IEEE P802.15
Wireless Personal Area Networks

Project	IEEE P802.15 Working Group for Wireless Personal Area Networks (WPANs)	
Title	TG3 D10 running comment resolutions	
Date Submitted	[8 July, 2002]	
Source	[James P. K. Gilb] [Apparent Technologies] [9921 Carmel Mountain Rd. #247, San Diego, CA 92129]	Voice: [858-538-3903] Fax: [858-538-3903] E-mail: [gilb@ieee.org]
Re:	[]	
Abstract	[This document is a record of comment resolutions for LB17.]	
Purpose	[To provide a record of the comment resolution for LB17.]	
Notice	This document has been prepared to assist the IEEE P802.15. It is offered as a basis for discussion and is not binding on the contributing individual(s) or organization(s). The material in this document is subject to change in form and content after further study. The contributor(s) reserve(s) the right to add, amend or withdraw material contained herein.	
Release	The contributor acknowledges and accepts that this contribution becomes the property of IEEE and may be made publicly available by P802.15.

1. Comment resolution, Vancouver to Schaumburg

Figure 2—MSC for the initiating of a neighbor piconet.

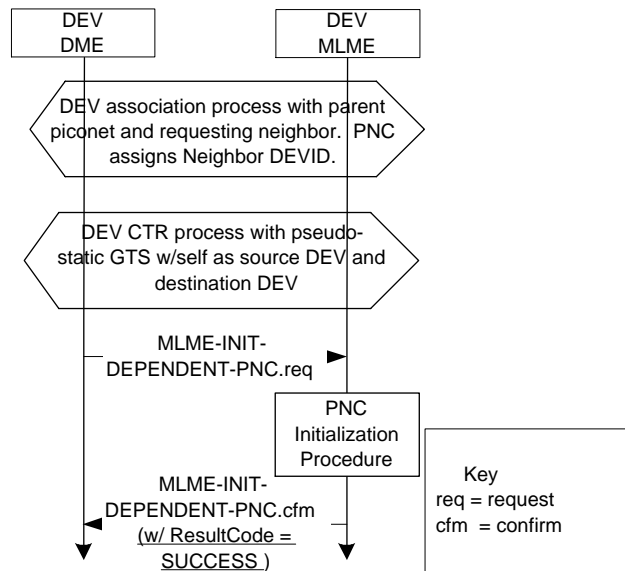
179 (Heberling, TR) - Figure 98 should be replaced with a proper MSC of the required protocol needed to establish a neighbor piconet. Replace figure 98 with a proper MSC. **Suggest accept** - An MSC for neighbor piconet initialization is included below. It needs twiddling to get the vertical lines to not show in the hex pro-

cess blocks. Also, although consistent with other similar diagrams, this MSC seems to need the first beacon of the neighbor PNC shown.

Accept in principle, “Accept suggested resolution but add a line at the bottom that shows the first beacon being sent. Also add after the sentence that says ‘The MSC for the initiation a neighbor piconet is illustrated in Figure 2.’ the following sentence, ‘The association and channel time request processes are defined in xref and xref, respectively.’”

Figure 3—MSC for the creating a child piconet.

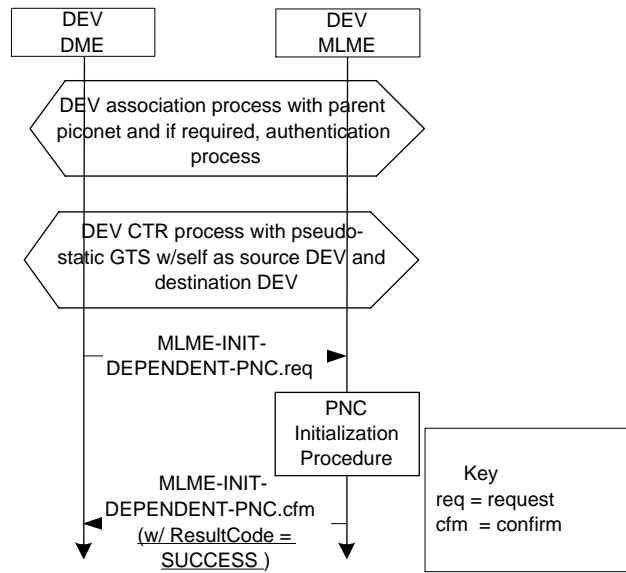
177 (Heberling, TR) - Figure 96 should be replaced with a proper MSC of the required protocol needed to establish a child piconet. Replace figure 96 with a proper MSC. **Suggest accept** 'An MSC for child piconet initialization is included below. It needs twiddling to get the vertical lines to not show in the hex process blocks. Also, although consistent with other similar diagrams, this MSC seems to need the first beacon of the child PNC shown.

Accept suggested resolution but add a line at the bottom that shows the first beacon being sent. Also add after the sentence that says 'The MSC for creating a child piconet is illustrated in Figure 3.' the following sentence, 'The association and channel time request processes are defined in xref and xref, respectively.'

Figure 119 – MSC for reserving asynchronous data channel time. Discussed earlier, new MSC is below:

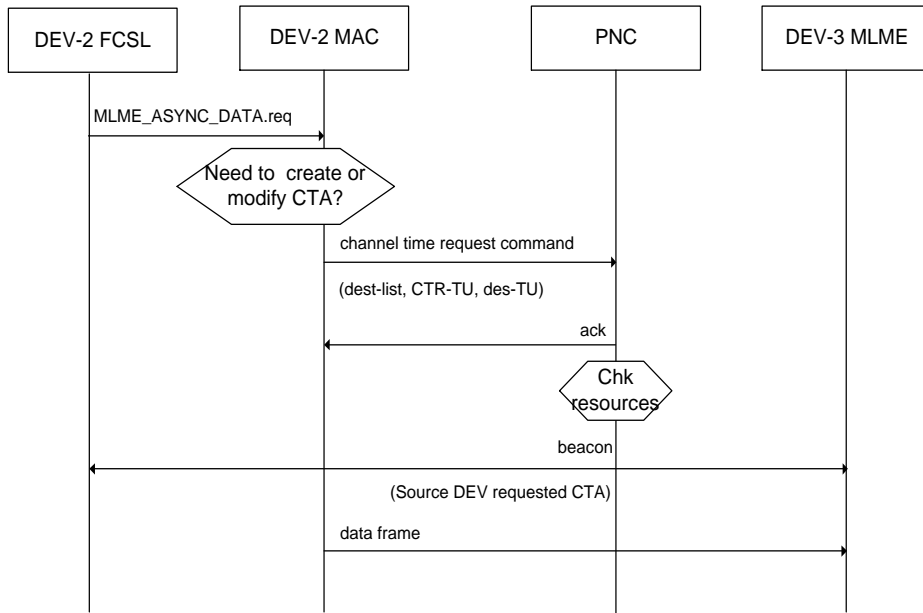
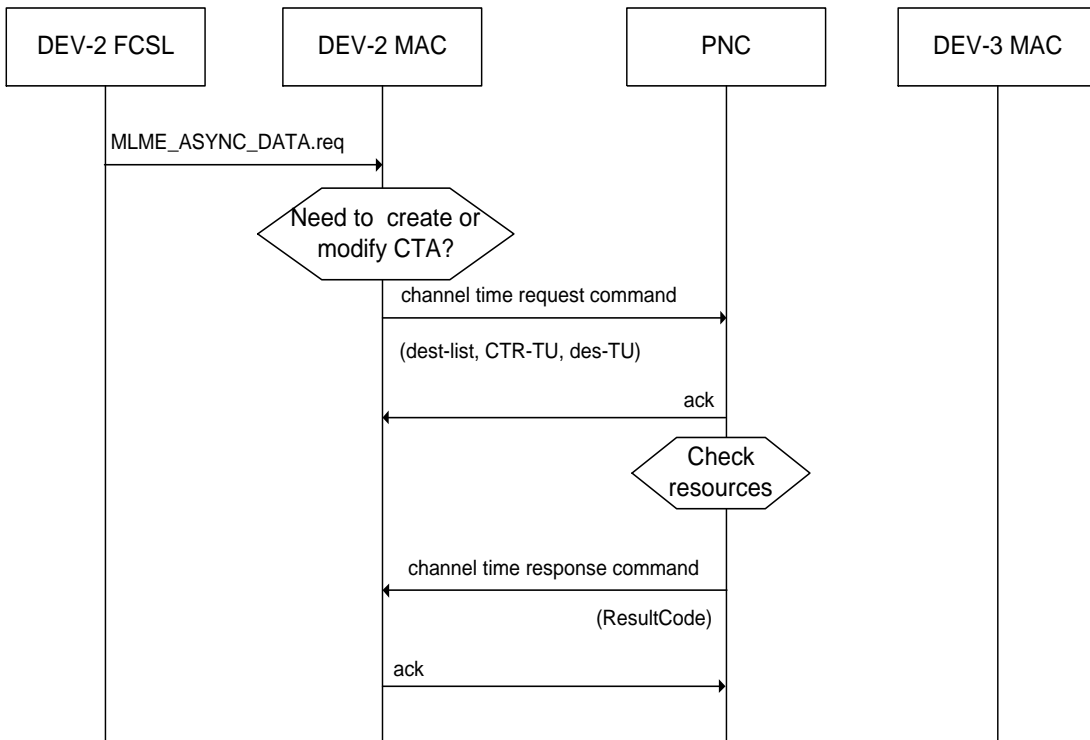
614, 652 (Gilb, T) The MLME-CREATE-CTA.req should be shown coming from the DEV-2 DME. What is "MAC-Q"? Also, the CL is no longer the packet CL but the FCSL (i.e. frame convergence sublayer). Consequently, change MAC-Q to be simply MAC. Change Packet CL to be FCSL in figure 4. **Accept in Principle** 1) replace MAC-Q and MLME with simply DEV-2 MAC. 2) Rename Packet CL to FCSL 3) Delete Figure 4 since it is duplicated in Figure 119. 4) Incorporate suggested changes identified in CID 327

914 (Bain, T) In figure 119, The PNC DME has the task of building the beacon. However, in the isochronous operation figures, the PNC MLME is shown to be building the beacon. Consequently, change the location of the build beacon element to the PNC MLME. **Suggest accept in principle** per CID 327

327 (Heberling, TR) Figure 119 is a flawed MSC of the Asynchronous channel time reservation process and data frame exchange. Consequently, delete the current MSC from this section of clause 8.5.2.1 and replace it with 02r0P802-15_TG3-Asynch-channel-time-allocation.eps. **Suggest accept**.

Figure 4—MSC for a approved asynchronous channel time request

Figure 5—MSC for a denied asynchronous channel time request
